MIL-S-9968C(IP)
AMENDMENT 1
16 September 1991

SKID , COMPONENTS, DOD REUSABLE

This amendment forms a part of MIL-S-9968C(IP), dated 26 September 1990, and is approved for use by all Departments and Agencies of the Oepartment of Defense.

FIGURE 1- RUNNER/ HEADER BEAM.

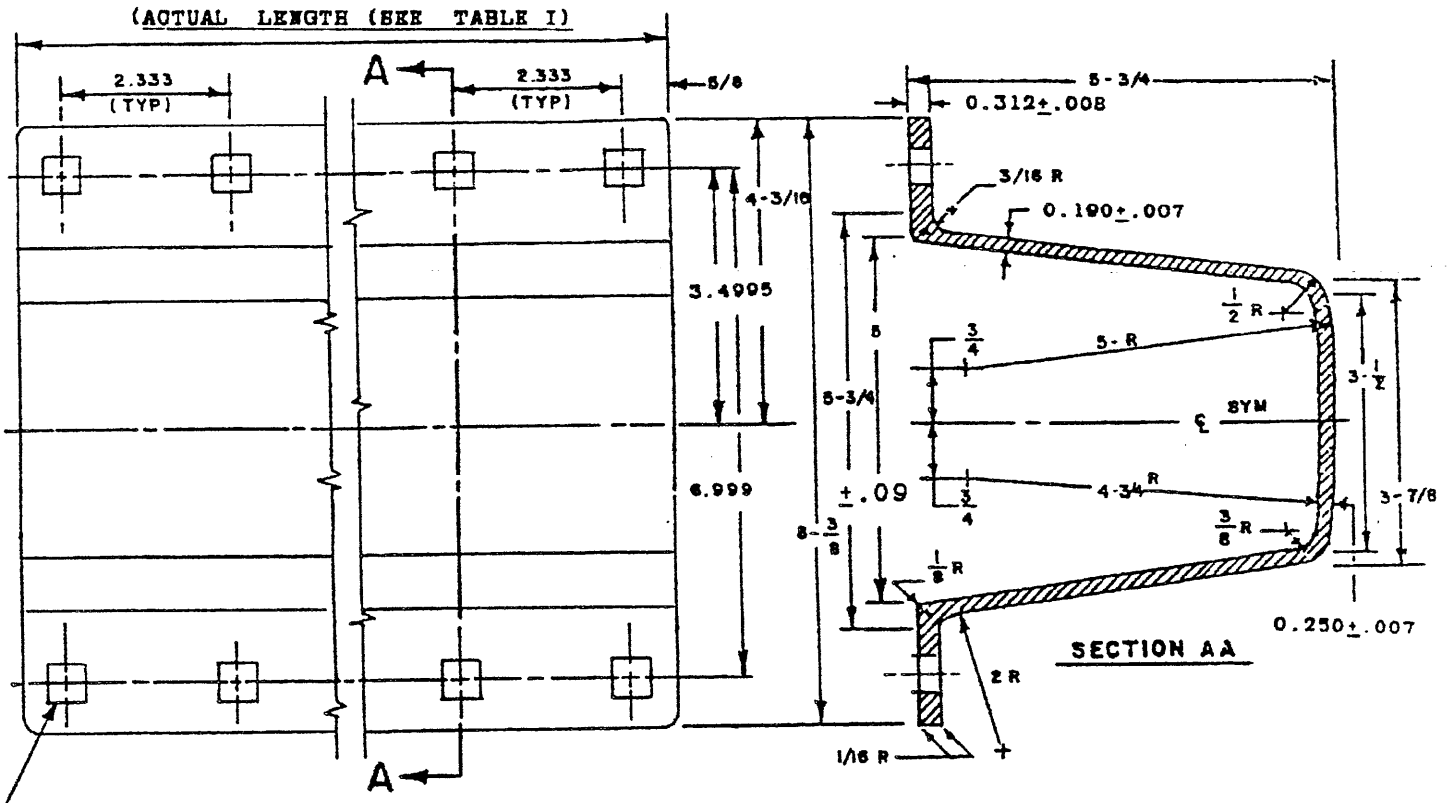
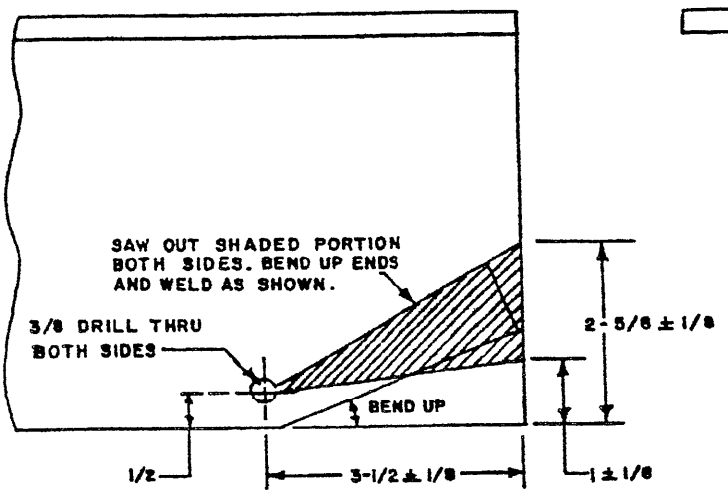
3.4.1, line 7: Delete and substitute

"The holes shall be longitudinally spaced on 2.333 inch centers within a tolerance of 0.010 inch non-cumulative for each hole."

Punch the number of 9/16 inch square holes specified by table I in each flange for the part number required. The holes shall be longitudinally spaced on 2.333 inch centers within a tolerance of ± 0.010 inch, non-cumulative for each hole. Measurements for extreme hole locations (ends of components) shall not exceed the cumulative tolerance specified in table I. Holes in flanges shall be in line with corresponding holes of opposite flanges within ±0.015 inch.

FIGURE 2 AUXILIARY TIE BAR.

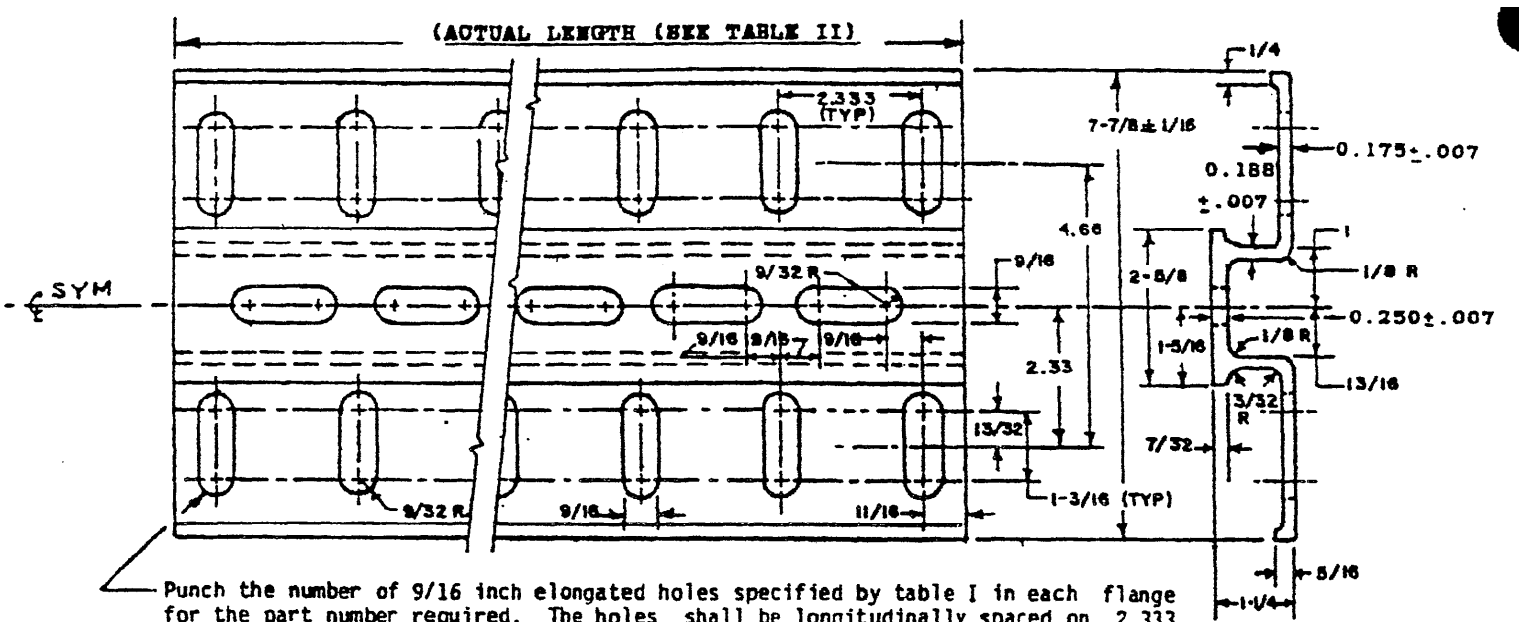
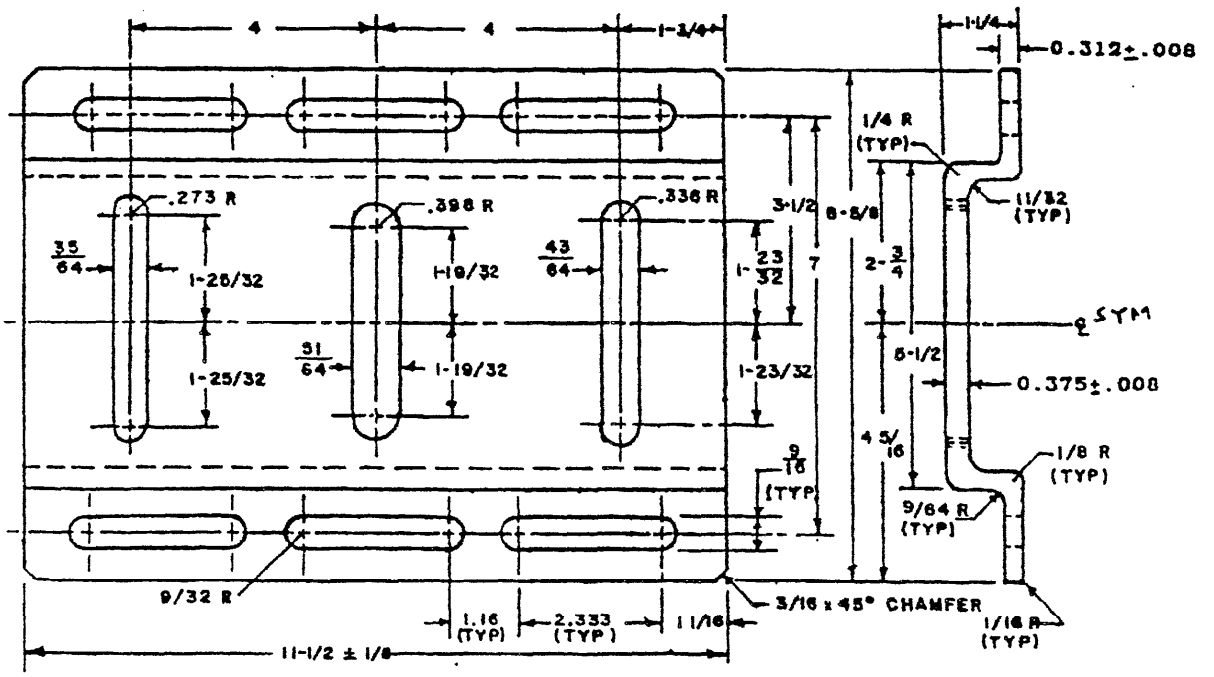
3.4.2, line 5: Delete and substitute:

"The holes shall be longitudinally spaced on 2.333 inch centers within a tolerance of ± 0.010 inch non-cumulative for each hole."

Punch the number of 9/16 inch elongated holes specified by table I in each flange for the part number required. The holes shall be longitudinally spaced on 2.333 inch centers within a tolerance of ±0.010 inch, non-cumulative for each hole. Measurements for extreme hole locations (ends of components) shall not exceed the cumulative tolerance specified in table II. Holes in flanges shall be in line with holes of opposite flanges within ±0.015 inch.
